Public Comment re MIRP

MIRP Impact
on
Water Quality
in
Gashouse Cove

July 2026

Figure 3 Gashouse Cove opening before the MIRP

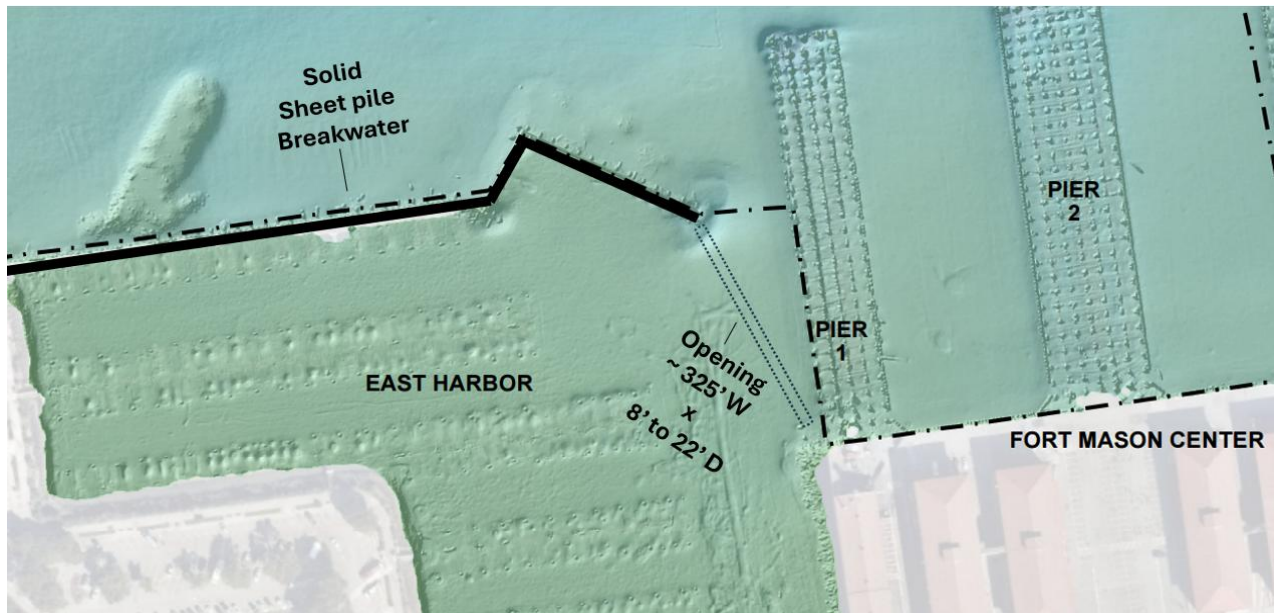
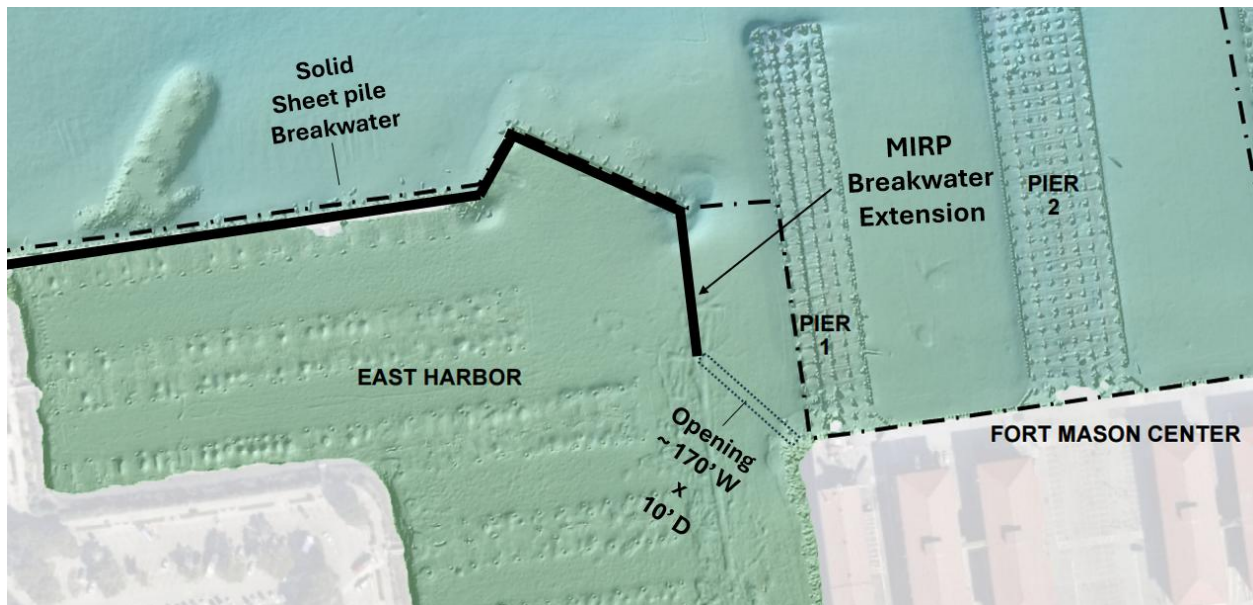
The openings with the existing breakwater, and with MIRP's 180' extension off its eastern tip, are depicted in Figures 3 and 6, respectively. Boats traverse north-south through the channel. Tidal ebbs and flows, however, also travel east-west (without MIRP) or northeast-southwest (with MIRP) through the opening. That's because Pier 1 blocks boats but does not block water flow. Tidal waters enter and exit Gashouse Cove between the tip of either breakwater and landfall at the intersection of Fort Mason Pier 1 and Building A. Fort Mason Pier 1 is a raised structure on piles; water flows freely beneath it at all tidal stages. The breakwater is impermeable — no water crosses it. Figure 7 is a general representation of the tidal flows and ebbs with the MIRP.

Although the MIRP reduces the opening by almost half, roughly 325 feet to 170 feet, it does not prevent Gashouse Cove from equilibrating with the tide. At all times, the sea level inside the cove is the same as the sea level in the Bay. This fact is important for the tidal prism analysis discussed below.

Figure 8 MIRP Engineering Specification for Surface Features

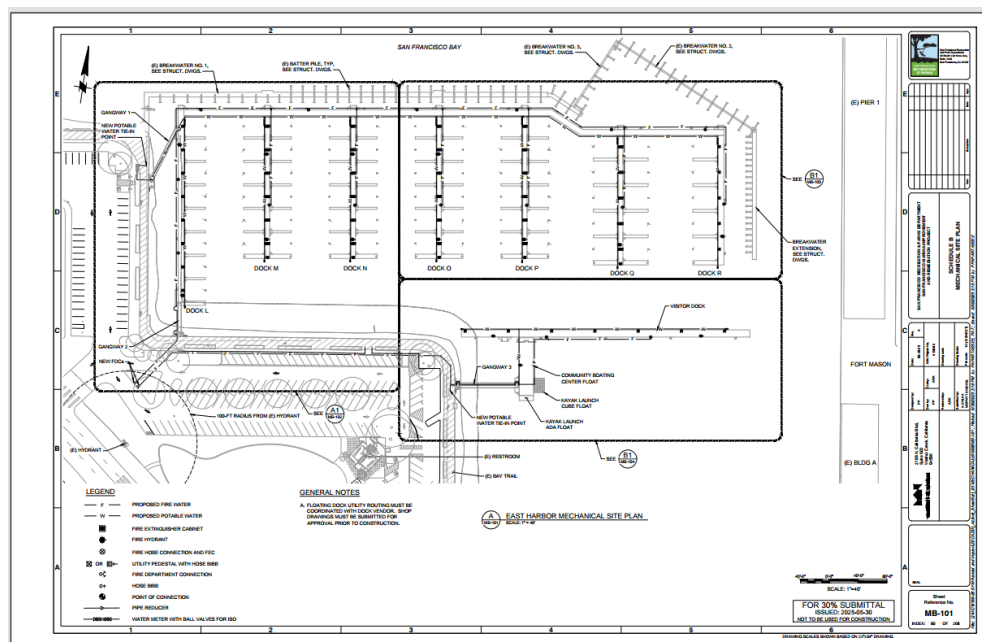
Surface water at flood tide enters at the opening and fans north, south, and west into Gashouse Cove. With the MIRP, the dense parallel array of approximately 165 finger slips shown in Figure 8 baffles surface flow progressively as water moves away from the opening. This reduces momentum and creates lower-circulation zones in the western and northern corners of North, farthest from the channel. Surface water reaches both North and South directly from the opening. The Visitor Dock running east-west across the middle of the cove does not obstruct surface flow near the opening but it inhibits surface flow between North and South. Overall, North will suffer the most from the poor exchange of surface water. North also suffers from the problems associated with moored boats and floating docks mentioned earlier.

Figure 9 Cross section of North's berthing and channel area³⁸

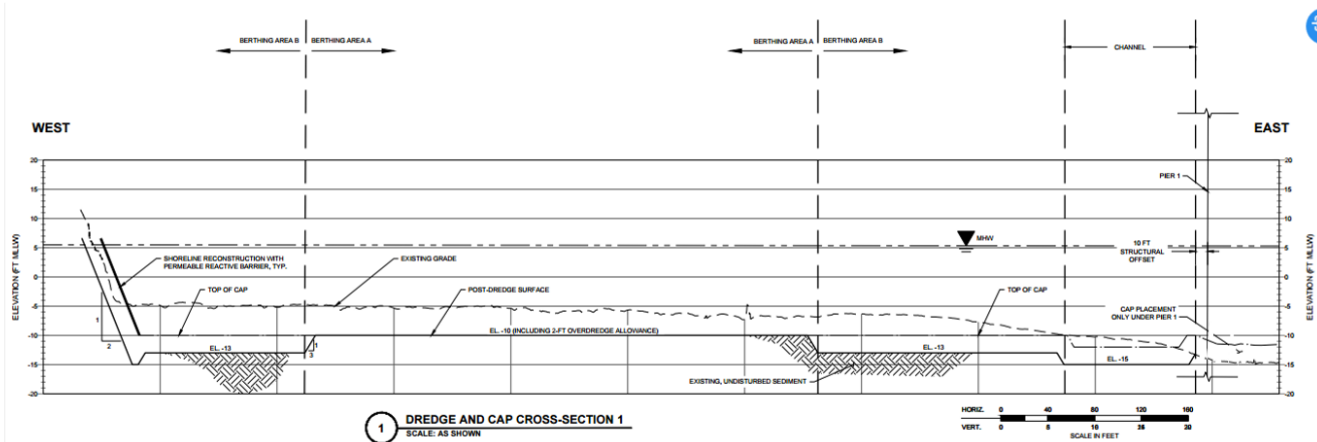
in the application or are not easily discernable from it. The east side (right hand side) of Figure 9 implies that the elevations under Pier 1 and at the bottom of the channel will be roughly the same, but the two will be separated by a small curb. Figure 10 implies that the channel is a trench. It's possible that this detail will not be known until it's built.

Regardless, it's evident that the deepest water entering Gashouse Cove will be constrained by the MIRP's bottom contours. While the Channel is at 10' MLLW, North (including berthing areas A and B) will be dredged to a design elevation of 8' MLLW. South will not be dredged but has a design elevation of 4' MLLW.² These three depths converge simultaneously at the mouth.

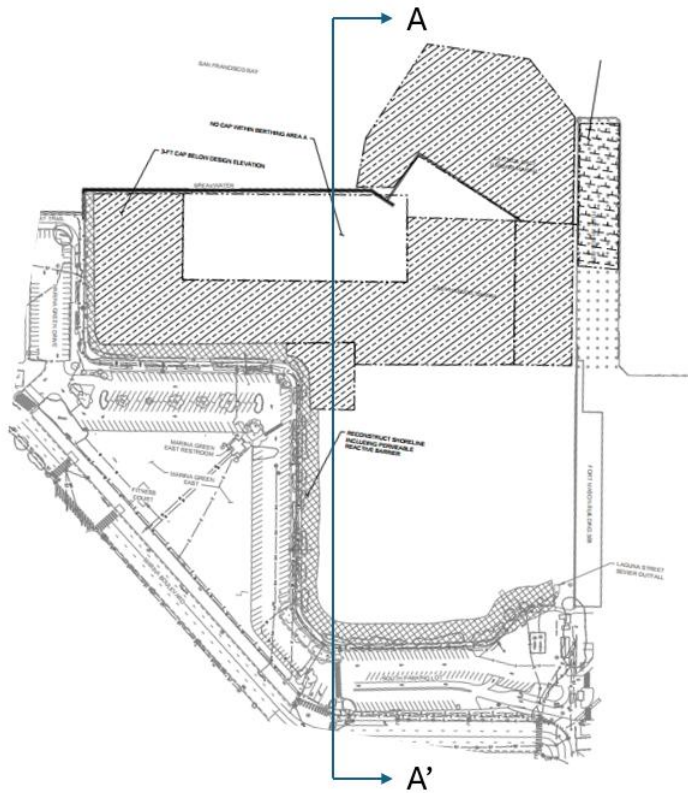
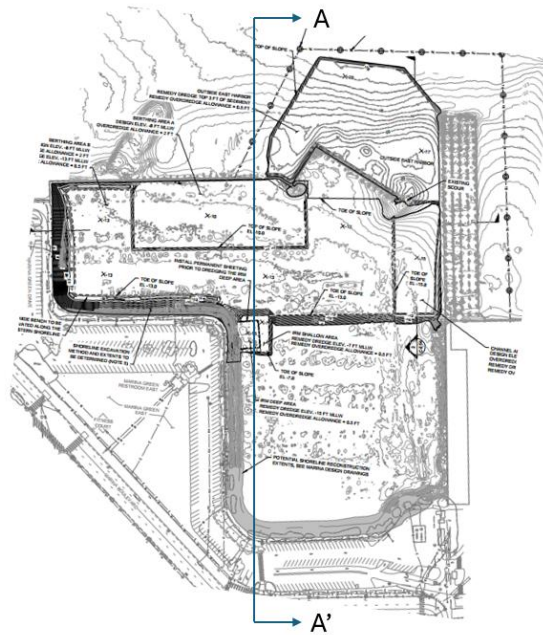
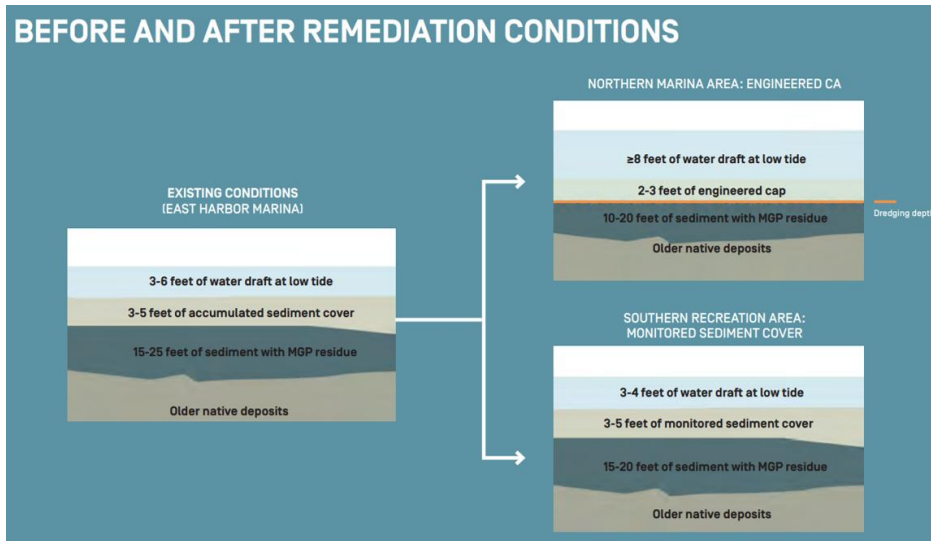
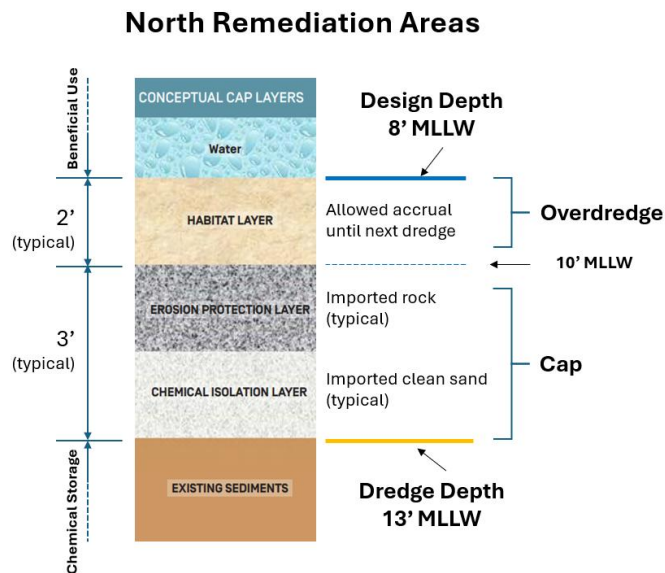
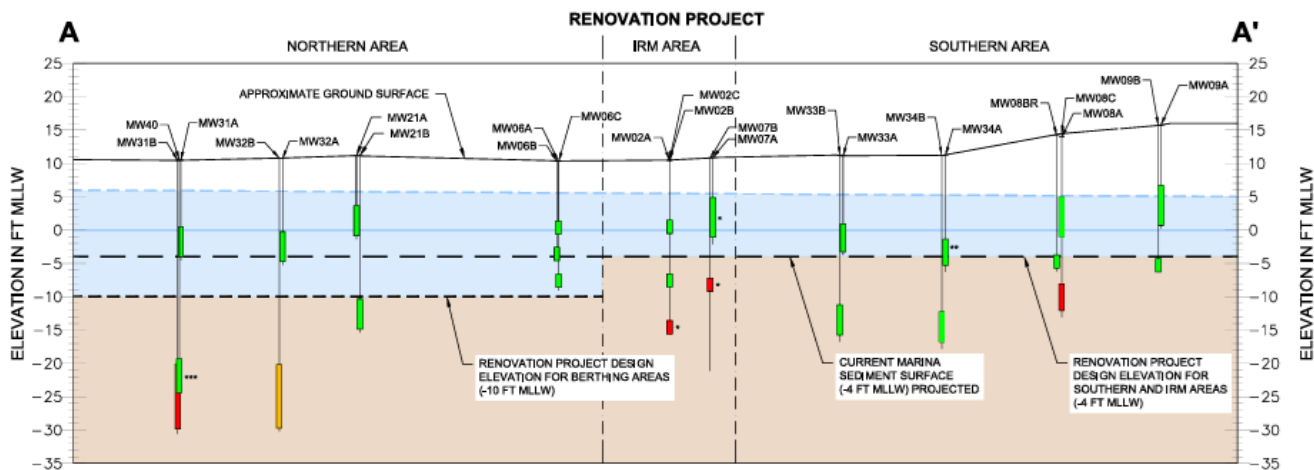
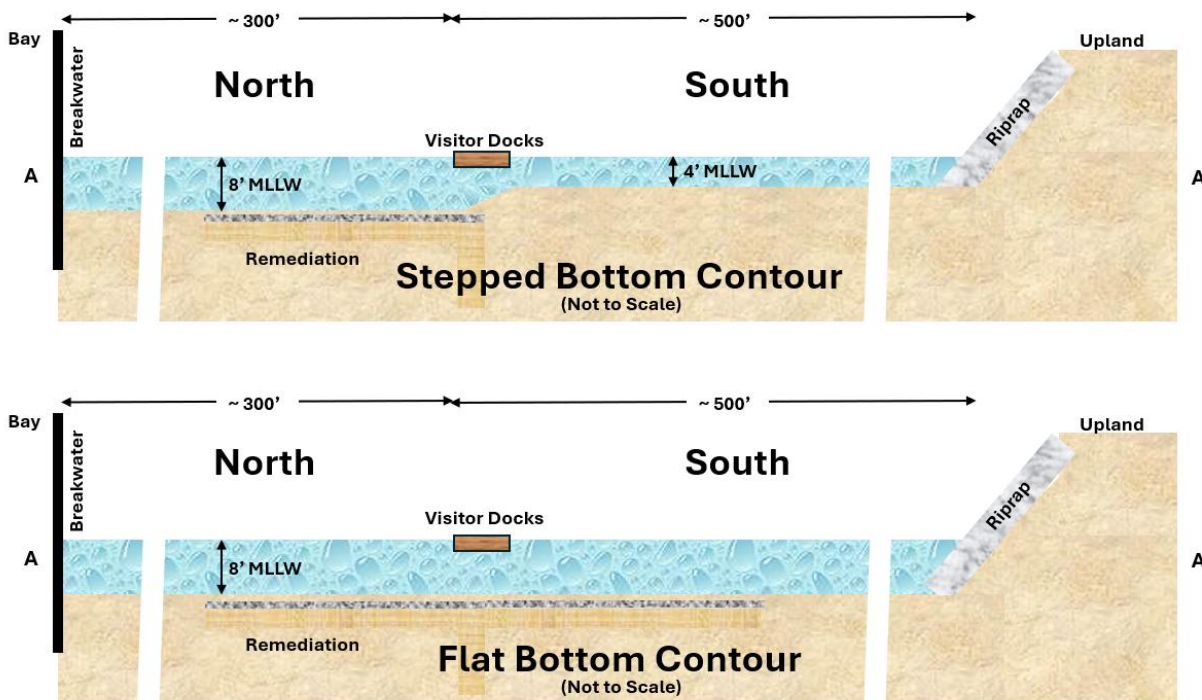
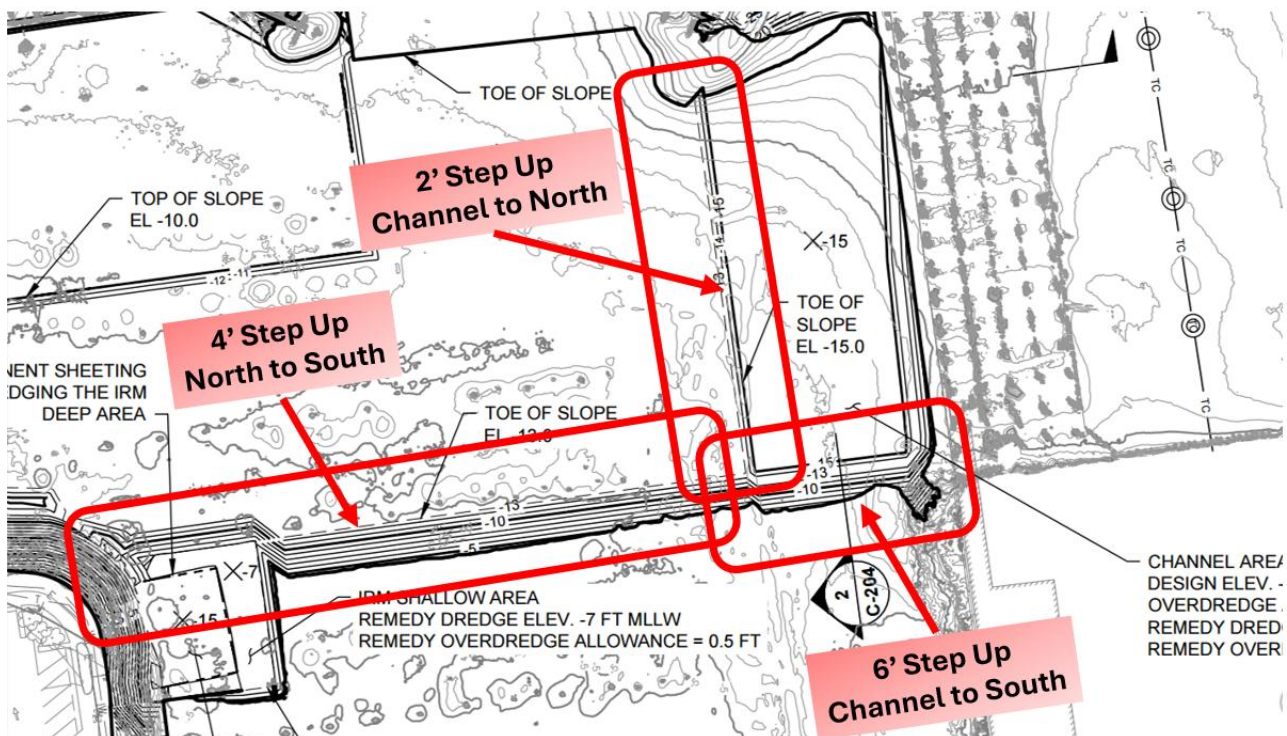
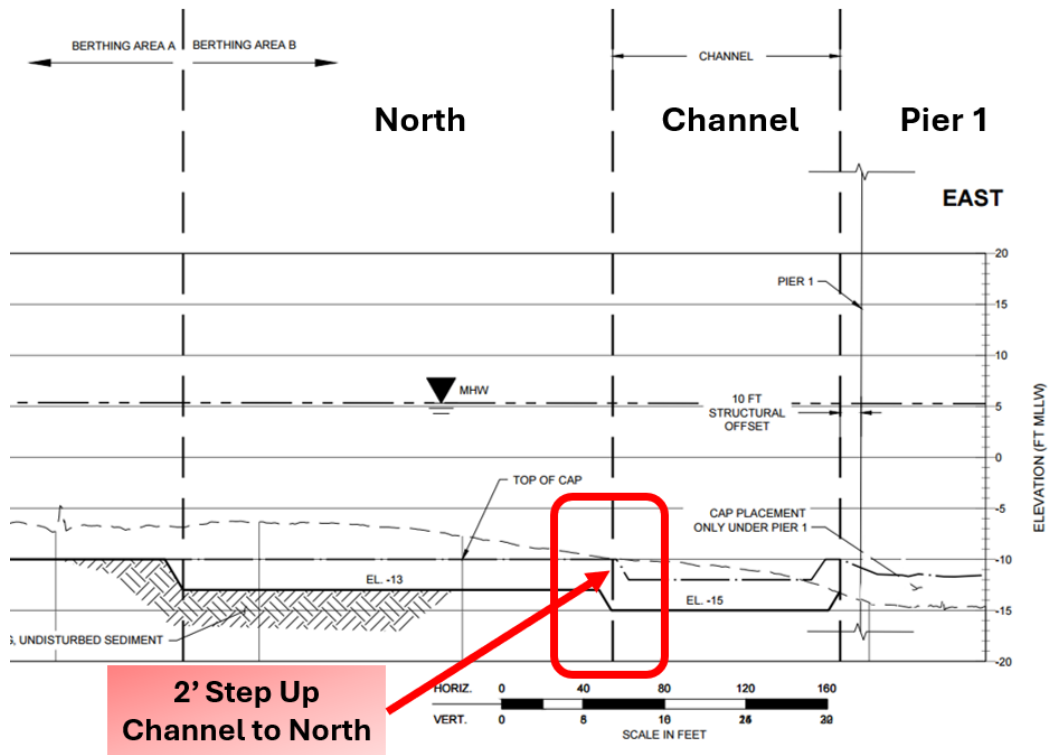
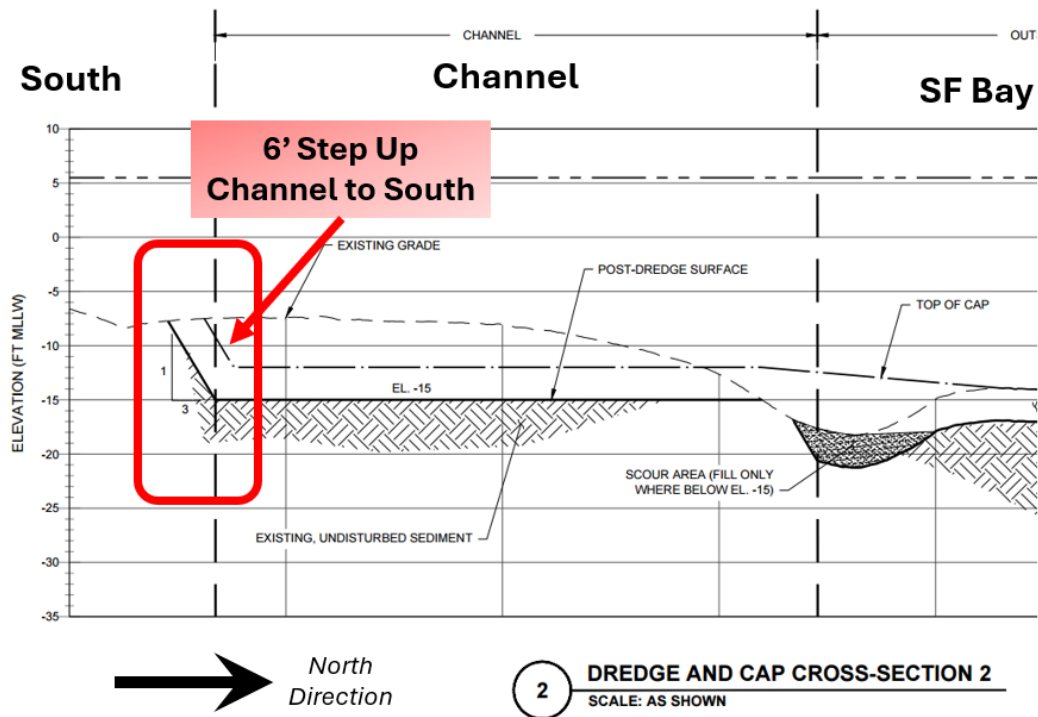
The MIRP's stepped bottom contour is detrimental to water quality in more critical way. Figures 11 through 20 describe the steps in detail gleaned from the MIRP application and related figures. The steps combine with the existing breakwater and breakwater extension to create a 850' x 300' x 4' deep trough under North's upper layers. A 120' opening to the channel means the trough is not fully enclosed... but it's still a bad design for water quality. The elongated shape, approximately 3:1, and baffling at the surface inhibits circulation patterns from organizing during flood and quiets flow. The trough will drain during ebb but it will not be draining well-mixed waters.

Figure 21 Current Bottom Contours showing Prop Wash Channel

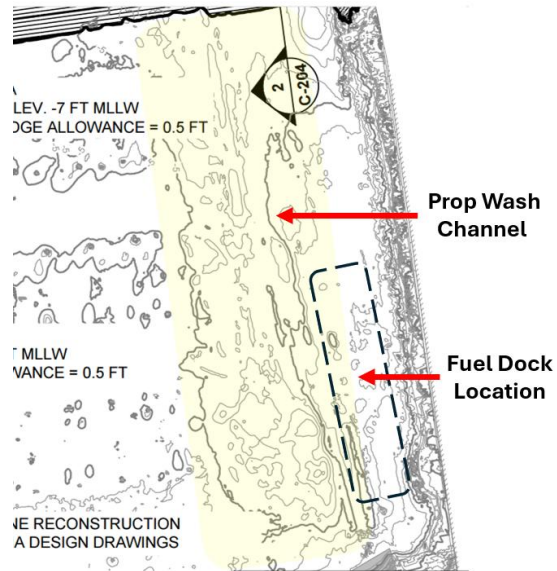
An exception is identified in Figure 21. While the rest of South silted up from years of neglect, prop wash from larger vessels using the fuel dock etched a channel parallel to the existing fuel dock. The existence of the prop wash channel makes the step-up from channel to South appear, in Figure 20, slightly less than the 6' design delta. It's a temporary anomaly with no effect on this analysis. It will disappear soon after the fuel dock is decommissioned.

Figure 22 Repeat of an unnumbered Figure from the Report

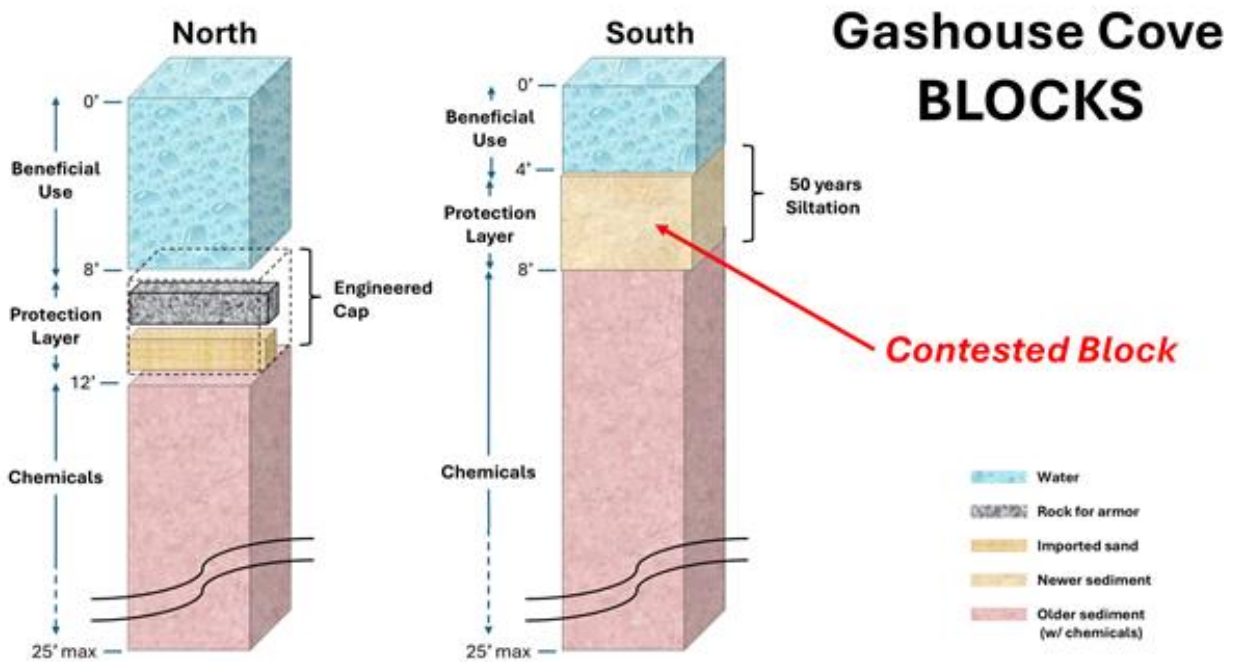
A discussion about MGP chemicals cannot end without mentioning the Water Board's decision to accept both remedies shown in figure 22. The Water Board has extensive

experience with engineered caps and no experience with using the contested block for protection.²⁶ At the same time, the Water Board has full confidence in its decision. The decision is based on sampling that has shown little or no contamination in shallow porewater where it might harm benthic organisms and no contamination in surface water where it might harm humans. Thus, the Water Board has – reasonably, given its perspective and its authority – determined that the MIRP is protective of health and the environment. It has stated that it will defend its decision until data proves otherwise.²⁷

To be clear, there is no data to prove otherwise. The MIRP may indeed be adequate to protect health and the environment. But there is risk. There are chemicals everywhere in the industrial world, most are unknown. Some have undoubtedly been in bays beneath several feet of clean sediment and done no harm to anyone or anything for centuries. But South is not remote and it's not a fenced-off industrial site. It's part of the most well-known and visited shoreline on earth. The plan is to use South for water contact sports and shoreline entertainment. The Water Board is making a defensible decision based on science and data but it is not giving enough weight to the location and use scenario. Gashouse Cove is known to be surrounded by chemicals. Its borders and everything in it is manmade except for the bottom. The more appropriate decision in this situation is to select the proven and robust protection method for South as is being done for North.
